Authors' response

Ms. Ref. No.: TSG-01404-2021

Title: Operationally-Safe Peer-to-Peer Energy Trading in Distribution Grids: A Game-Theoretic

Journal: IEEE Transactions on Smart Grid

Figure 2: Incorporating storage units causes a peak-shaving effect on the sum of the total power imported from the main grid and the power locally generated.

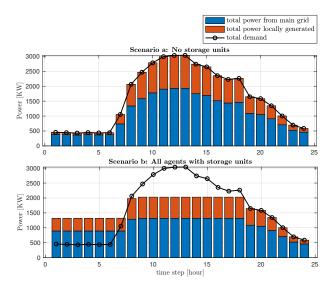
R3-6: Please, check Figure 7. The authors claim that storage help in shaving the peak of total power imported from the main grid, but this looks the same in both figures.

Answer: We thank the Reviewer for providing this observation. What we claim is that the storage shaves the peak of the sum of the total power imported from the main grid and that of locally generated power. Indeed, due to the choice of the cost parameters, which follows [Atzeni et al., 2013], local generation costs are cheaper than importing cost. We have redone the simulations where we readjust the cost parameters and introduce a positive quadratic coefficient on f_i^{di} . Due to this adjustment, we can now see in Figure 7 in the revised manuscript (as also shown below) that the storage particularly shaves the peak of total power imported from the main grid.
